**Application No.: PL8625**

Description :	
Address :	
Record Type :	PLAT

# PLAT OF: FLOUR BLUFF HEIGHTS BLOCK 4, LOT 13R AND 14R

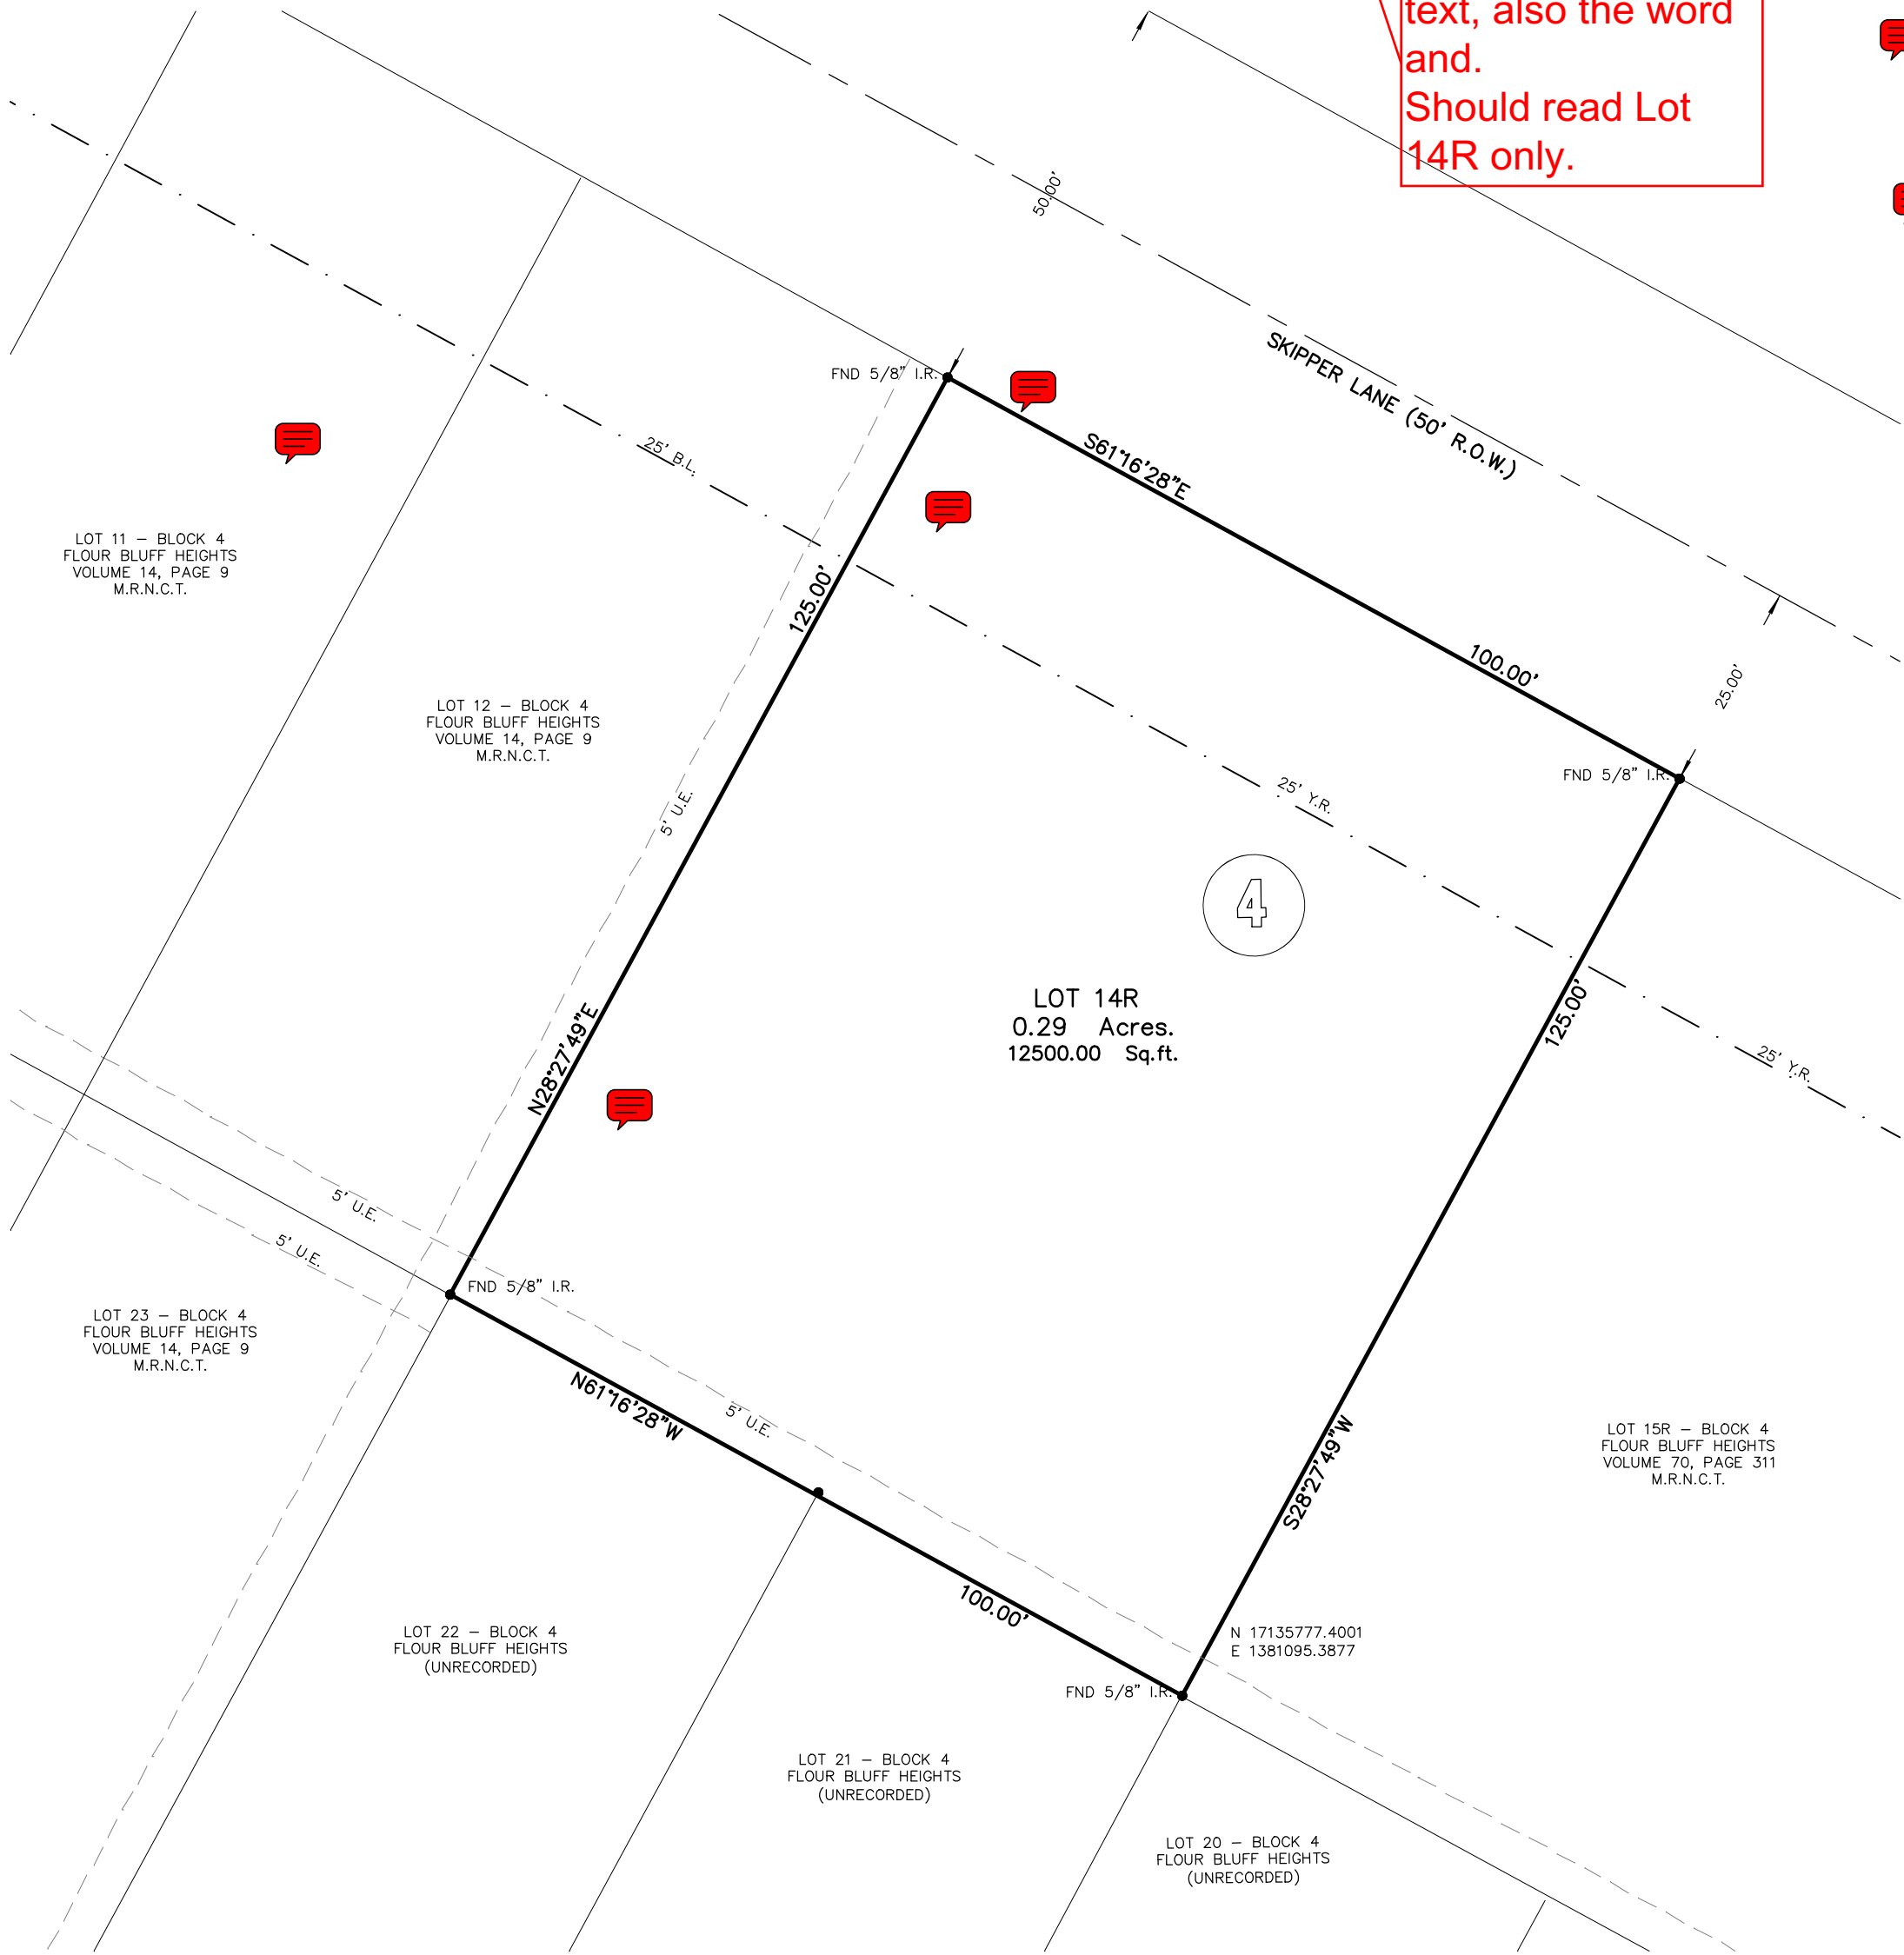
9	P001	Callout	Mark Zans : LD	Closed	Remove Lot 13R text, also the word and. Should read Lot 14R only.	
10	P001	Note	Mark Zans : LD	Closed	Be advised this property is in the APZ-1 zone for aircraft fly overs. Place a general note on the plat stating that the property is subject to aircraft fly over, noise and vibration	
13	P001	Note	Mark Zans : LD	Closed	Plat is a replat creating one lot.	
14	P001	Note	Mark Zans : LD	Closed	Plat is a Non-public notice PC plat

Comment ID	Page Reference	Annotation Type	Author : Department	Status	Review Comments	Applicant Response Comments
2	1	Note	Alex Harmon : DS	Open		
3	1	Note	Alex Harmon : DS	Open	Is there an Electrical easement on lot for the power pole or did survey show pole in right of way? If on property show/provide easement on plat.	
4	1	Note	Alex Harmon : DS	Open	Add plat note: During the development of the site, any increase in stormwater runoff flow rates must be mitigated in accordance with UDC 8.2.8.A, 8.2.8.B, and IDM 3.05 resulting in no adverse impacts between existing conditions and proposed conditions.	
7	1	Note	Alex Harmon : DS	Open	Show 6" PVC waterline to show there is a connection available for servicing of plat.	
11	1	Note	Alex Harmon : DS	Open	Include estimated water and wastewater usage on utility plan to ensure the proposed development is in compliance with the Comprehensive Plan, implementation plan and applicable Utility Master Plan and the availability and capacity of public improvements needed to support the development. (Flow units gpd) UDC 3.8.5.D

9	1	Callout	Mark Zans : LD	Open	Remove Lot 13R text, also the word and. Should read Lot 14R only.	
10	1	Note	Mark Zans : LD	Open	Be advised this property is in the APZ-1 zone for aircraft fly overs. Place a general note on the plat stating that the property is subject to aircraft fly over, noise and vibration	
13	1	Note	Mark Zans : LD	Open	Plat is a replat creating one lot.	
14	1	Note	Mark Zans : LD	Open	Plat is a Non-public notice PC plat	
15	1	Note	Mark Zans : LD	Open	This plat is on the 30-day tract for approval, approval with Conditions, or disapproval by 4/2/2025. The deadline for revisions to be submitted is 3/24/2025.	
16	1	Note	Mark Zans : LD	Open	A request or response may be made for an additional 30 days for Public Notice plat with a Waiver or to resolve Open comments. This request must be made directly to Development Services within the 30-day initial period.	
19	1	Note	Mark Zans : LD	Open	Parks Fee: Park fee of \$462.50 for one new residential unit will be charged. Fee must be paid prior to recordation of the plat.

21	1	Note	Mark Zans : LD	Open	Depict LCRA easement for overhead power lines. At this time awaiting LCRA communication to determine easement width.

Remove Lot 13R  
text, also the word  
and.  
Should read Lot  
14R only.
